Historic District Commission

Wednesday, July 15, 2020

COA-2016-01, Modification #1 – Rooftop Solar PV System – 85 Emerald Street

COA-2016-06, Modification #6 – Washington Park Modifications – 31 Washington Street

Figure 2. An image submitted by the applicant showing the location of the Rapid Shutdown Switch along the eastern façade of the building located at 85 Emerald Street.

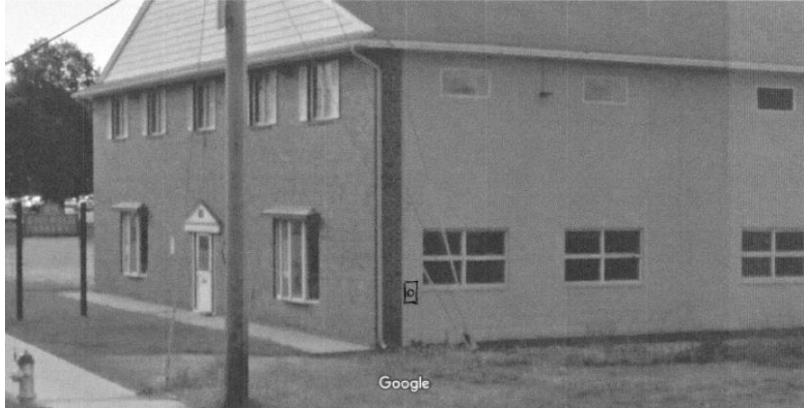
The applicant has specified that the only ancillary piece of equipment that will be installed on the exterior of the building is a “Rapid Shutdown Switch” measuring 4”x 6” that will be installed in a gray metal box and will be mounted at the southeastern corner of the building, along the eastern building façade. The applicant has noted that this equipment will be screened to traffic heading east on Emerald Street by the southern building façade, which extends 5” beyond the eastern block wall. The applicant has submitted an image (see Figure 2) showing the location of the Rapid Shutdown Switch on the eastern façade, along with a sketch showing how the southern façade will serve as a screening mechanism for the switch. The Rapid Shutdown Switch would be visible to traffic headed west on Emerald Street, as shown in Figure 3. The applicant has stated that they are willing to paint the metal box that the Rapid Shutdown Switch will be located in to match the color of the existing block wall.

Approve COA-2016-01, Modification #1 for the installation of a rooftop solar PV system on the western-facing portion of the roof of the building located at 85 Emerald Street (TMP# 584-072-000) as presented in the application and supporting materials submitted to the Community Development Department on June 24, 2020 with no conditions.

Rivest/85 Emerald Street Solar Project 6/15/2020

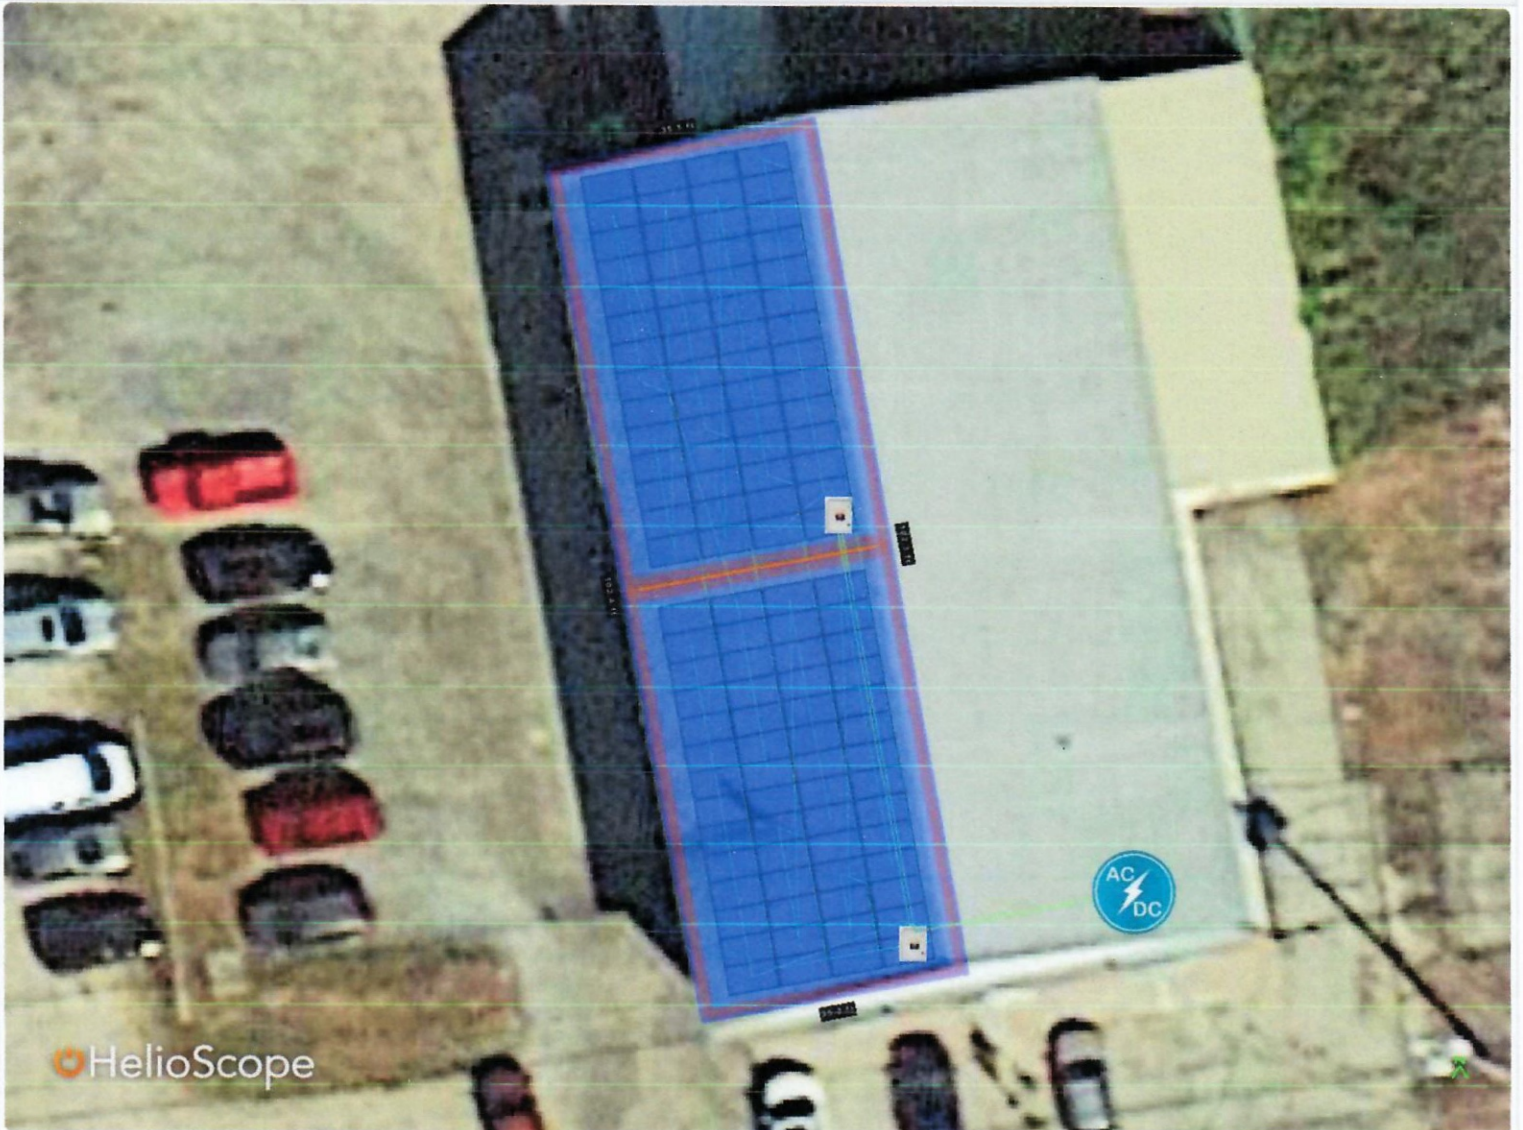
The applicant proposes to install the rooftop solar PV system on the western portion of the roof using “Flush Mount” racking that will sit 4” above the existing roof surface and will be tilted at a 25 degree angle to match the existing roof pitch. The solar array will be visible to traffic traveling north or south along School Street and traffic headed east on Emerald Street. The applicant has stated that this is the most feasible location for the solar array due to space constraints on the site and due to the fact that there are no additions/structures, secondary roofs, newer roofs, or flat roofs on which an array of the appropriate size could be sited. This standard appears to be met.

The rooftop plan submitted by the applicant shows the rooftop solar PV system configured in a rectangular arrangement along the western of portion of the roof with an access aisle down the middle, which is required by Fire Code. The applicant has specified that the solar panels will be set back a minimum of 18” from the ridge of the roof and will have an access aisle measuring at least 36” wide. This standard appears to be met.

Figure 2. A photo of the proposed vent caps that was submitted by the applicant.

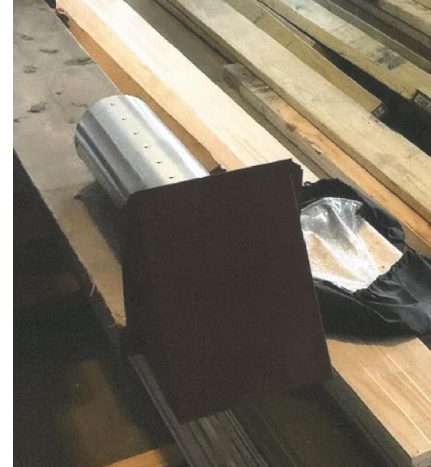
The applicant notes that the 16 proposed, 4” diameter vent penetrations are required for bathroom and kitchen exhaust in the 8 apartments. Eight of the penetrations will be drilled through the HardiePlank siding on the northern façade of the northeastern section of the former Middle School building, as shown on the rendering attached to this staff report. The other eight vent penetrations will be drilled in a similar configuration on the southern façade of this section of the building, facing MoCo Arts. Figure 2 shows the design of the square, brown metal vent caps that will be installed in these vent penetrations.
